January 18, 2017

SUBJECT: Transmittal of Corrections to EPRI Report 3002005349, *Materials Reliability Program: Pressurized Water Reactor Internals Inspection and Evaluation Guidelines (MRP-227, Revision 1)*

Subject: **Transmittal of Corrections to EPRI Report 3002005349, Materials Reliability Program: Pressurized Water Reactor Internals Inspection and Evaluation Guidelines (MRP-227, Revision 1)**

Figure 3-4  
 Typical CE Welded Core Shroud with Full Height Panels (with Bottom-Mounted ICI)

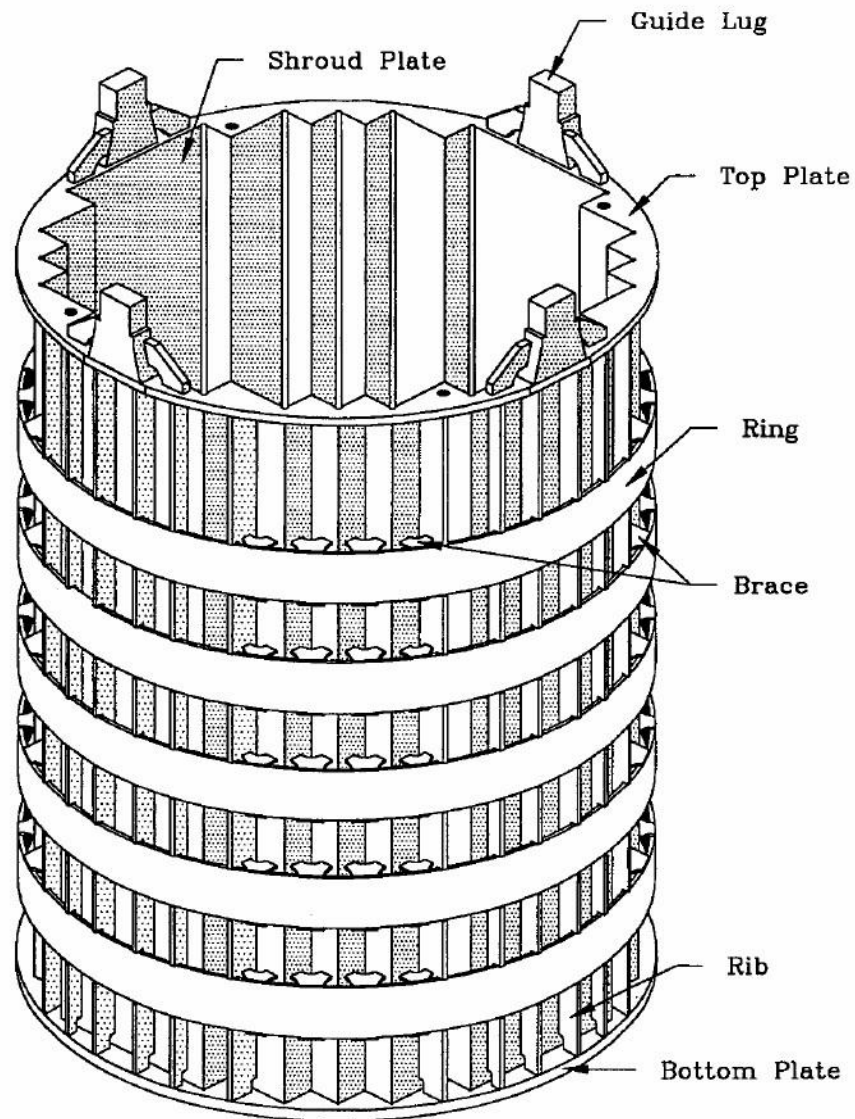
On pages 3-8 (Figure 3-3), 3-9 (Figure 3-4) and 4-47 through 4-68 (Figures 4-11 through Figure 4-37), the figure captions have been modified to improve clarity. These are general representations of the internals components, and the word ‘typical’ has been added to the beginning of each figure caption.

“Note: Figure intended to represent the component features and relative position to other portions of the structure and system. Figure does not contain or transmit design information and is not meant to be used for performing engineering assessments, evaluations, or examinations.”

*Figure 4-28*  
*Typical CE-Design Core Shroud Assembly (Bolted) Assembly*

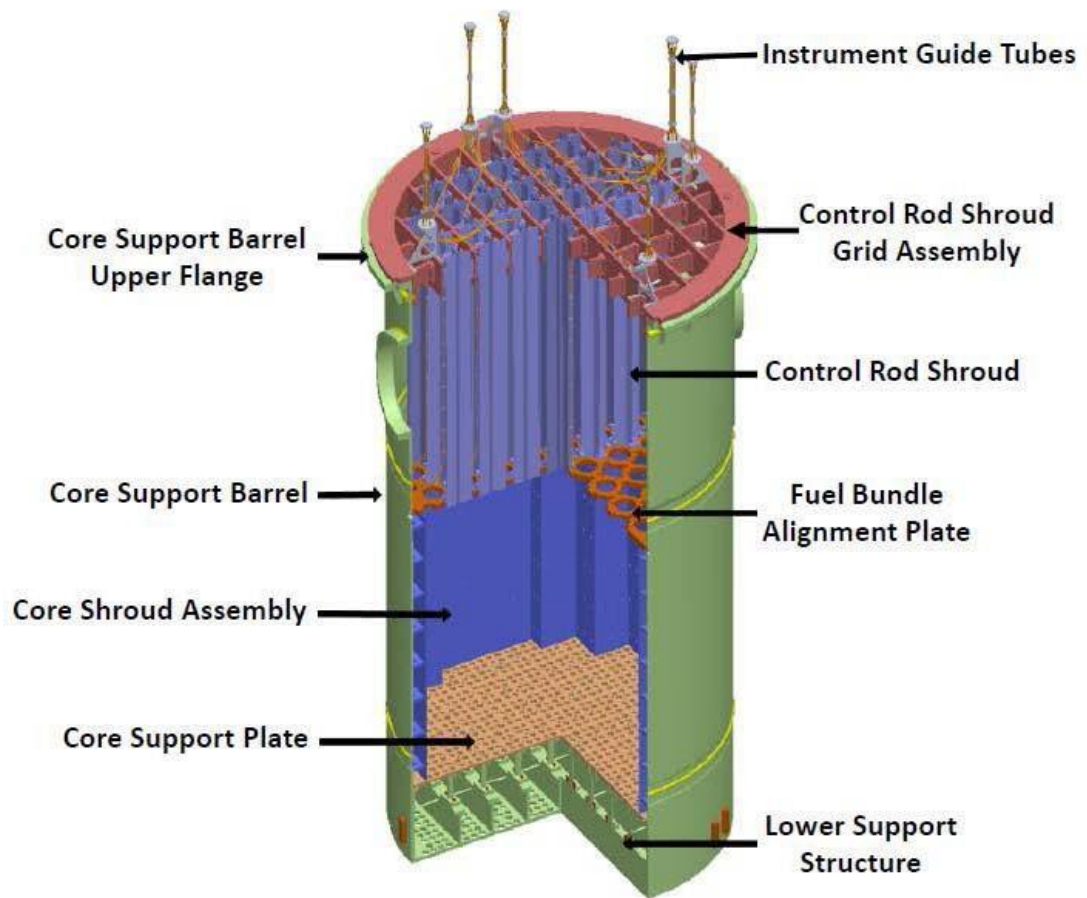
| MRP-227 Revision 1 Figure call-out errors identified in Table 4.2 |             |                    |                    |
|---|-------------|--------------------|--------------------|
| C9.   | 4-19        | 4-31               | 4-28               |

| Primary Item   | Applicability   | Effect (Mechanism)  | Expansion Link | Examination Method/Frequency (Note 1)  | Examination Coverage   |
|--|---|---|----------------|--|--|
| <b>C9.Lower Support Structure</b><br>Core support plate            | All plants with a core support plate                                    | Cracking (Fatigue)<br>Aging Management (IE)   | None           | If screening for fatigue cannot be satisfied by plant-specific evaluation, enhanced visual (EVT-1) examination, no later than 2 refueling outages from the beginning of the license renewal period. Subsequent examination on a ten-year interval.         | Examination coverage to be defined by evaluation to determine the potential location and extent of fatigue cracking.<br><br>See Figure 4-28  |

*Typical CE-Design Core Support Barrel Assembly - Welds, Upper Cylinder (Including Welds), Upper Core Barrel Flange, Core Barrel Assembly Axial Welds, Lower Core Barrel Flange*

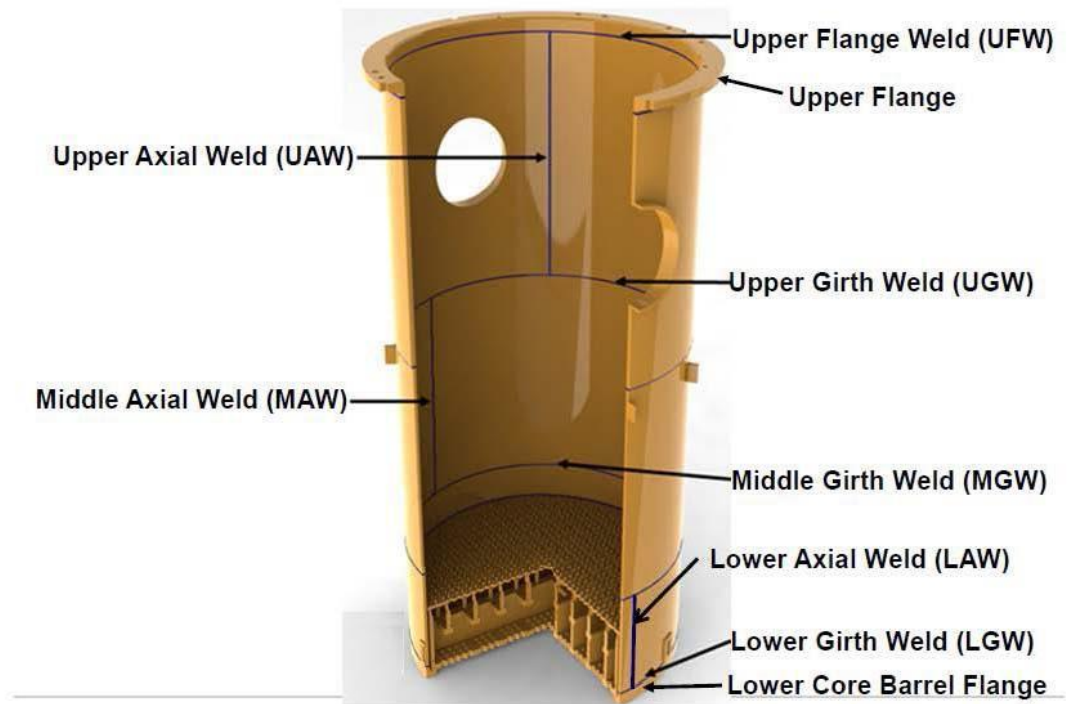
| MRP-227 Revision 1 Figure call-out errors identified in Table 4.5 |             |                    |                    |
|---|-------------|--------------------|--------------------|
| C5.1  | 4-28        | 4-29               | 4-29 and 4-30      |

| Expansion Item  | Applicability   | Effect (Mechanism)  | Primary Link (Note 1)      | Examination Method/Frequency (Note 1)  | Examination Coverage   |
|---|---|---|----------------------------|--|--|
| <b>Core Support Barrel Assembly</b><br>C5.1.Lower Girth Weld (LGW)                                    | All plants  | Cracking (SCC, Fatigue)   | C5.Upper Flange Weld (UFW) | Enhanced visual (EVT-1) examination.<br>Re-inspection every 10 years following initial inspection. | A minimum of 75% of the OD circumferential of the LGW and adjacent base metal shall be examined.<br><br>See Figures 4-29 and 4-30. |

*Figure 4-31  
Typical CE-Design Upper Internals Assembly Fuel Alignment Plate*

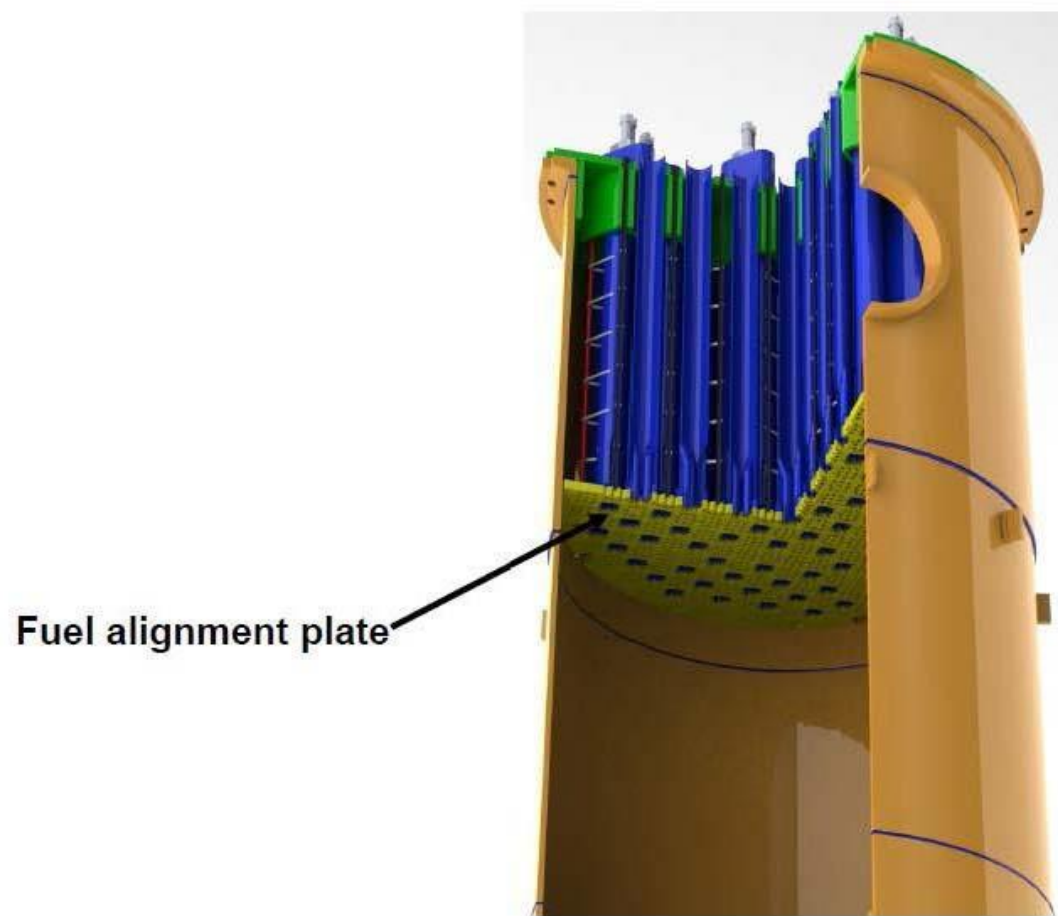
| MRP-227 Revision 1 Figure call-out errors identified in Table 4.2 |             |                    |                    |
|---|-------------|--------------------|--------------------|
| C10.  | 4-20        | 4-32               | 4-31               |

| Primary Item  | Applicability   | Effect (Mechanism)  | Expansion Link (Note 1)   | Examination Method/Frequency (Note 1)  | Examination Coverage  |
|---|---|---|---|--|---|
| <b>C10.Upper Internals Assembly</b><br>Fuel alignment plate   | Only plants with welded core shrouds assembled with full-height shroud plates | Cracking (Fatigue), Aging management (IE)   | None  | If screening for fatigue cannot be satisfied by plant-specific evaluation, enhanced visual (EVT-1) examination, no later than 2 refueling outages from the beginning of the license renewal period. Subsequent examination on a ten-year interval. | Examination coverage to be defined by evaluation to determine the potential location and extent of fatigue cracking.<br><br>See Figure 4-31.  |

*Figure 4-32  
Typical CE-Design Control Element Assembly Instrument Guide Tubes*

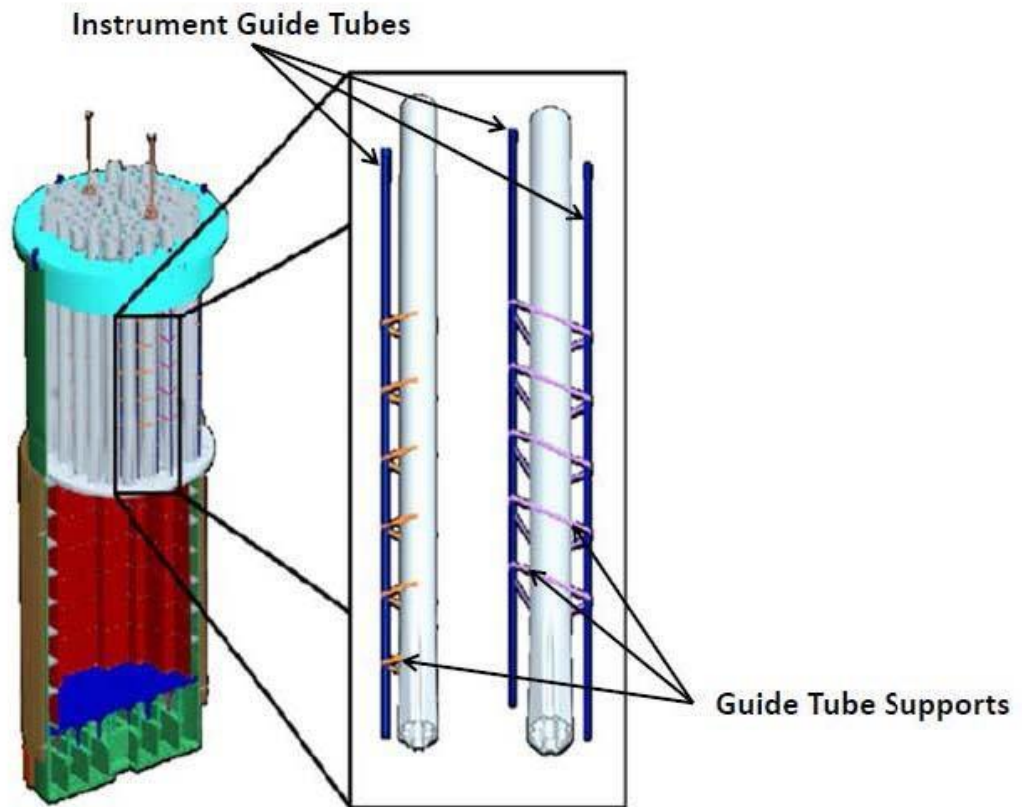
| MRP-227 Revision 1 Figure call-out errors identified in Table 4.2 |             |                    |                    |
|---|-------------|--------------------|--------------------|
| C11.  | 4-20        | 4-33               | 4-32               |

| MRP-227 Revision 1 Figure call-out errors identified in Table 4.5 |             |                    |                    |
|---|-------------|--------------------|--------------------|
| C11.1   | 4-29        | 4-33               | 4-32               |

| Primary Item  | Applicability   | Effect (Mechanism)  | Expansion Link (Note 1)   | Examination Method/Frequency (Note 1)  | Examination Coverage  |
|---|---|---|---|--|---|
| <b>C11.Control Element Assembly</b><br>Instrument guide tubes | All plants with instrument guide tubes attached to the CEA shroud assemblies  | Cracking (SCC, Fatigue) that results in missing supports or separation at the welded joint between the tubes and supports   | Remaining instrument guide tubes within the CEA shroud assemblies | Visual (VT-3) examination, no later than 2 refueling outages from the beginning of the license renewal period. Subsequent examination on a ten-year interval.  | 100% of instrument guide tubes in peripheral CEA shroud assemblies (i.e., those adjacent to the perimeter of the fuel alignment plate), focusing on the supports and the connecting welds between the supports and the guide tube and CEA shroud.<br><br>See Figure 4-32. |

| Expansion Item   | Applicability   | Effect (Mechanism)   | Primary Link (Note 1)  | Examination Method/Frequency (Note 1)  | Examination Coverage  |
|--|---|--|--|--|---|
| <b>Control Element Assembly</b><br>C11.1.Remaining instrument guide tubes                  | All plants with instrument guide tubes in the CEA shroud assembly             | Cracking (SCC, Fatigue) that results in missing supports or separation at the welded joint between the tubes and supports. | C11.Peripheral instrument guide tubes within the CEA shroud assemblies | Visual (VT-3) examination.<br>Re-inspection every 10 years following initial inspection.           | 100% of tubes in CEA shroud assemblies (minimum of 75% of the total population of remaining instrument guide tubes) focusing on the supports and the connecting welds between the supports and the guide tube and CEA shroud.<br><br>See Figure 4-32. |

*Figure 4-33*  
*Typical CE-Design Lower Support Structure Deep Beams*

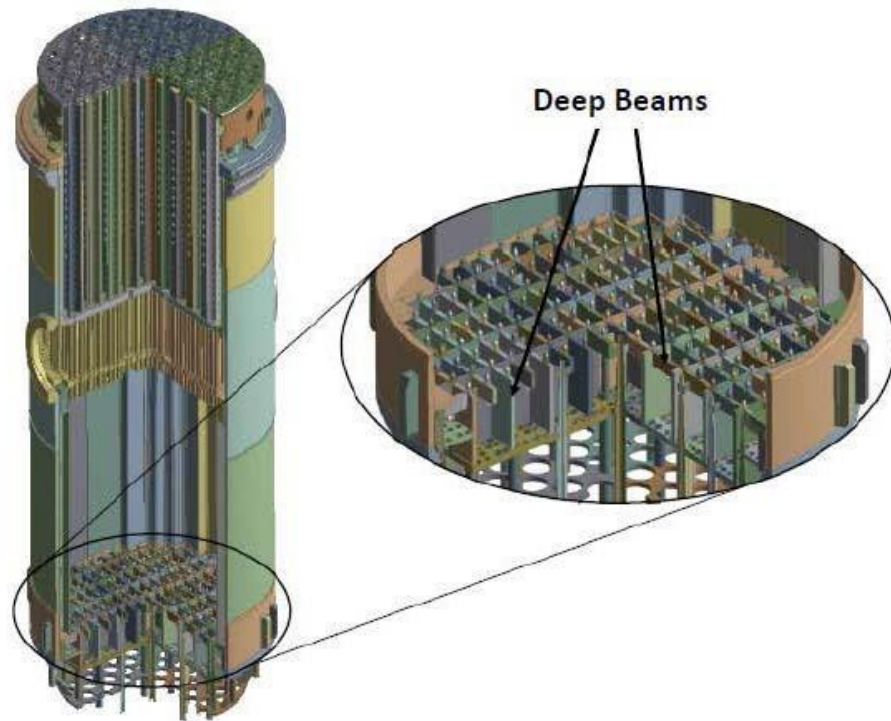
| MRP-227 Revision 1 Figure call-out errors identified in Table 4.2 |             |                    |                    |
|---|-------------|--------------------|--------------------|
| C12.  | 4-20        | 4-34               | 4-33               |

| Primary Item  | Applicability   | Effect (Mechanism)  | Expansion Link (Note 1)   | Examination Method/Frequency (Note 1)  | Examination Coverage  |
|---|---|---|---|--|---|
| <b>C12.Lower Support Structure</b><br>Deep beams              | Only plants with welded core shrouds assembled with full-height shroud plates | Cracking (Fatigue) that results in a detectable surface-breaking indication in the welds or beams.<br>Aging Management (IE) | None  | Enhanced visual (EVT-1) examination, no later than 2 refueling outages from the beginning of the license renewal period. Subsequent examination on a ten-year interval, if adequacy of remaining fatigue life cannot be demonstrated.              | Examine 25% of the total number of beam-to-beam welds. Coverage on each weld includes the top four inches of the weld in the vertical orientation.<br><br>See Figure 4-33.  |

*Figure 4-34  
Typical CE-Design Core Shroud Assembly (Bolted) Barrel Shroud Bolts*

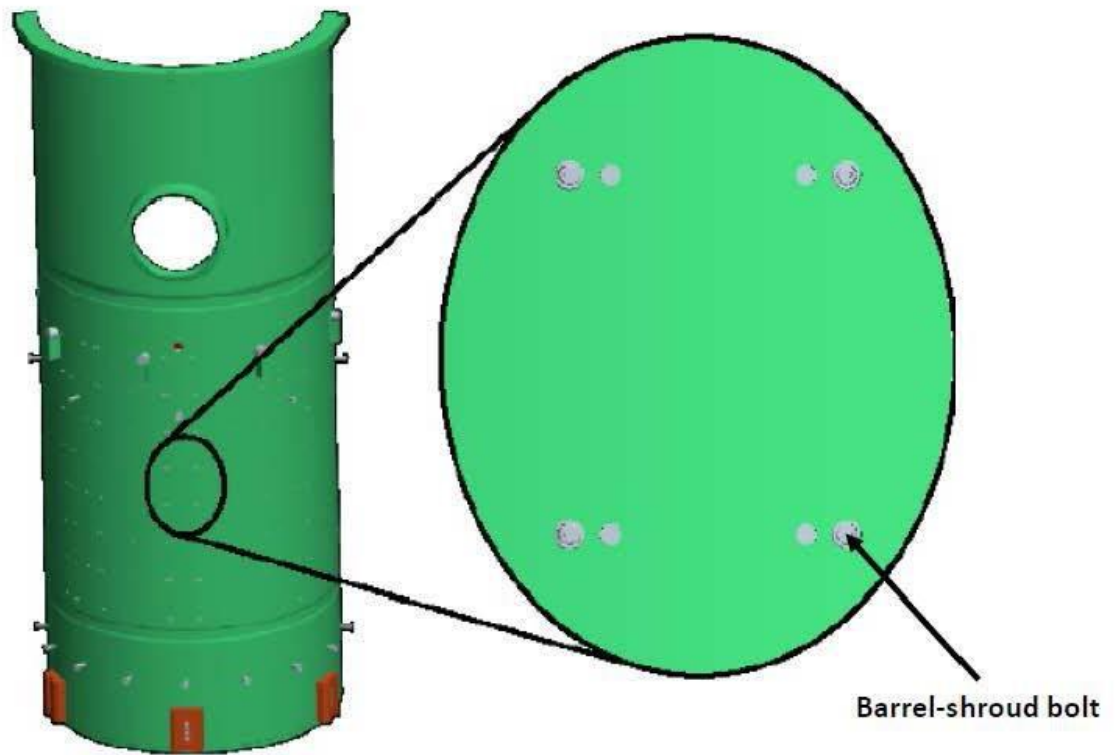
| MRP-227 Revision 1 Figure call-out errors identified in Table 4.5 |             |                    |                    |
|---|-------------|--------------------|--------------------|
| C1.2  | 4-28        | 4-35               | 4-34               |

| Expansion Item  | Applicability   | Effect (Mechanism)  | Primary Link (Note 1)      | Examination Method/Frequency (Note 1)  | Examination Coverage   |
|---|---|---|----------------------------|--|--|
| <b>Core Shroud Assembly (Bolted)</b><br>C1.2.Barrel-shroud bolts                                      | Bolted plant designs  | Cracking (IASCC, Fatigue)<br>Aging Management (IE and ISR)      | C1.Core shroud bolts       | Volumetric (UT) examination.<br>Re-inspection every 10 years following initial inspection.         | 100% of accessible barrel-shroud bolts or as supported by plant-specific justification.<br><br>See Figure 4-34.                    |

Figure 4-35\*  
*Typical CE-Design Lower Support Structure Lower Core Support Beams*

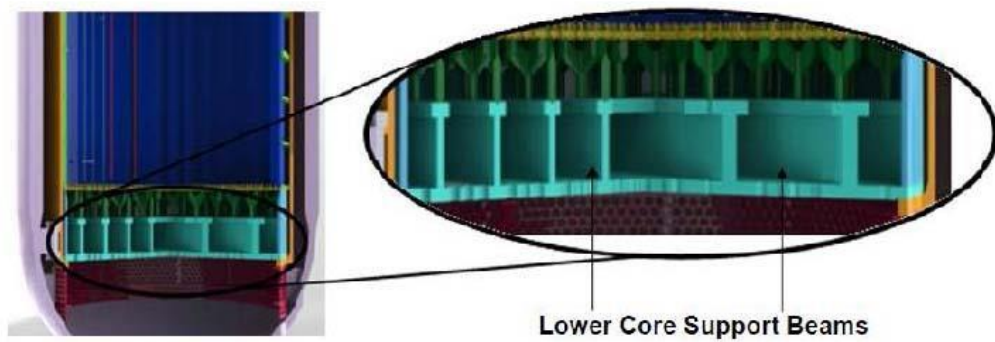
| MRP-227 Revision 1 Figure call-out errors identified in Table 4.5 |             |                    |                    |
|---|-------------|--------------------|--------------------|
| C5.4  | 4-28        | 4-36               | 4-35               |

| Expansion Item  | Applicability   | Effect (Mechanism)  | Primary Link (Note 1)      | Examination Method/Frequency (Note 1)  | Examination Coverage   |
|---|---|---|----------------------------|--|--|
| <b>Lower Support Structure</b><br>C5.4.Lower core support beams                                       | All plants except those with welded core shrouds assembled with full-height shroud plates | Cracking (SCC, Fatigue) including damaged or fractured material | C5.Upper Flange Weld (UFW) | Enhanced visual (EVT-1) examination.<br>Re-inspection every 10 years following initial inspection. | 25% of welds and adjacent base metal or locations as justified by plant-specific evaluation.<br><br>See Figure 4-35.               |

Figure 4-36\*  
*Typical CE-Design Core Shroud Assembly (Bolted) Core Support Column Bolts*

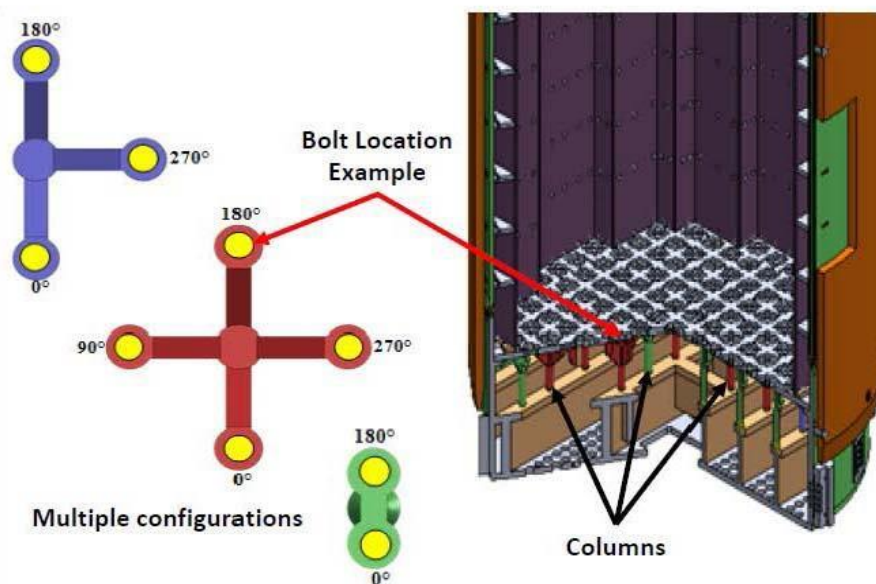
| MRP-227 Revision 1 Figure call-out errors identified in Table 4.2 |             |                    |                    |
|---|-------------|--------------------|--------------------|
| C8.   | 4-19        | 4-31               | 4-36               |

| MRP-227 Revision 1 Figure call-out errors identified in Table 4.5 |             |                    |                    |
|---|-------------|--------------------|--------------------|
| C1.1  | 4-29        | 4-37               | 4-36               |

| Primary Item   | Applicability   | Effect (Mechanism)  | Expansion Link | Examination Method/Frequency (Note 1)  | Examination Coverage   |
|--|---|---|----------------|--|--|
| <b>C8.Lower Support Structure</b><br>Core support columns          | Plants with full-height bolted or half-height welded core shroud plates | Cracking (SCC, IASCC, Fatigue including damaged or fractured material)<br><br>Aging Management (IE, TE) | None           | Visual (VT-3) examination no later than 2 refueling outages from the beginning of the license renewal period. Subsequent examinations on a ten-year interval.  | Plants with full height bolted core shroud plates: 25% of column assemblies as visible using a VT-3 examination from above the lower core plate.<br><br>Plants with core shrouds assembled in two vertical sections: 100% of the accessible surfaces of the core support column welds, from the top side of the core support plate (Note 3).<br><br>See Figure 4-36. |

| Expansion Item   | Applicability   | Effect (Mechanism)   | Primary Link (Note 1)  | Examination Method/Frequency (Note 1)  | Examination Coverage  |
|--|---|--|--|--|---|
| <b>Core Shroud Assembly (Bolted)</b><br>C1.1.Core support column bolts                     | Bolted plant designs  | Cracking (IASCC, Fatigue)<br>Aging Management (IE)   | C1.Core shroud bolts   | Ultrasonic (UT) examination.<br>Re-inspection every 10 years following initial inspection.         | 100% (or as supported by plant-specific analysis) of core support column bolts (Minimum of 75% of the total population).<br><br>See Figure 4-36.  |

*Typical CE-Design Core Shroud Assembly (Welded) Remaining Axial Welds, Ribs and Rings*

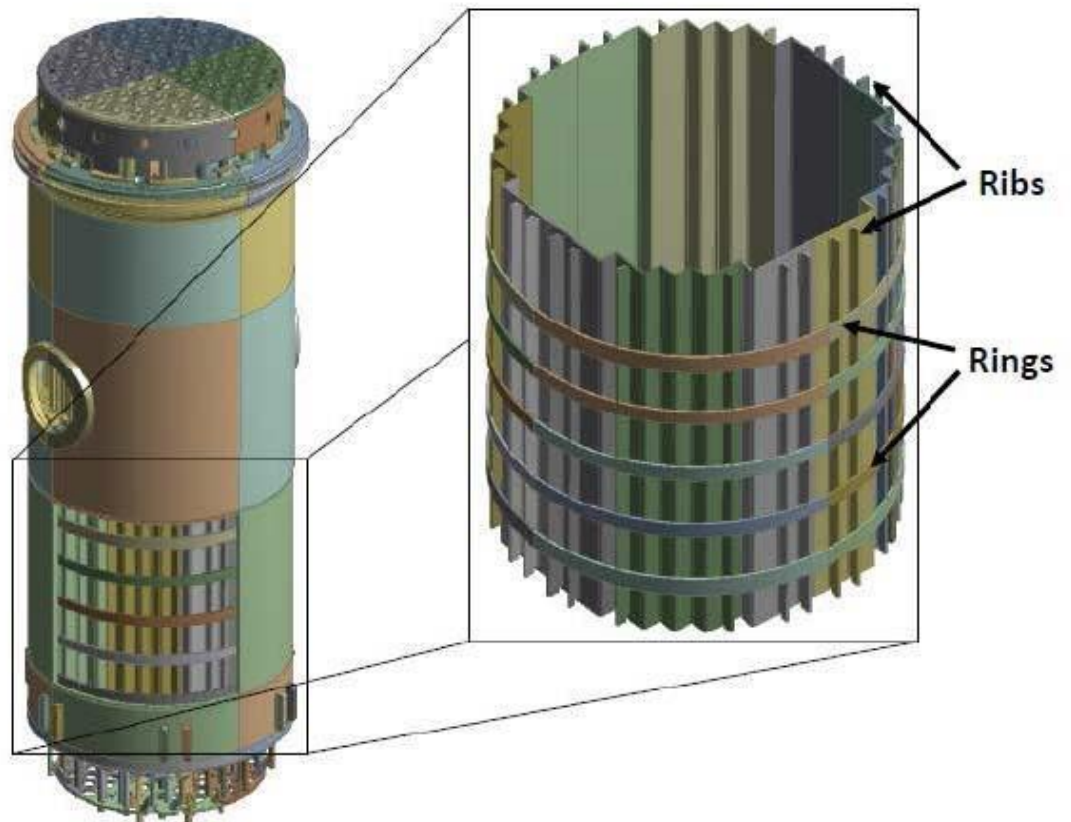
| MRP-227 Revision 1 Figure call-out errors identified in Table 4.5 |             |                    |                    |
|---|-------------|--------------------|--------------------|
| C3.1/3.2  | 4-29        | 4-38               | 4-37               |

| Expansion Item   | Applicability   | Effect (Mechanism)   | Primary Link (Note 1)  | Examination Method/Frequency (Note 1)  | Examination Coverage  |
|--|---|--|--|--|---|
| <b>Core Shroud Assembly (Welded)</b><br>C3.1.Remaining axial welds,<br>C3.2.Ribs and rings | Only plants with welded core shrouds assembled with full-height shroud plates | Cracking (IASCC),<br>Aging Management (IE)   | C3.Shroud plates of welded core shroud assemblies                      | Enhanced visual (EVT-1) examination.<br>Re-inspection every 10 years following initial inspection. | 75% of the remaining axial weld length and adjacent base metal as visible from the core side of the shroud other than that already inspected under the primary link.<br>25% of the ribs and rings.<br><br>See Figure 4-37.                            |
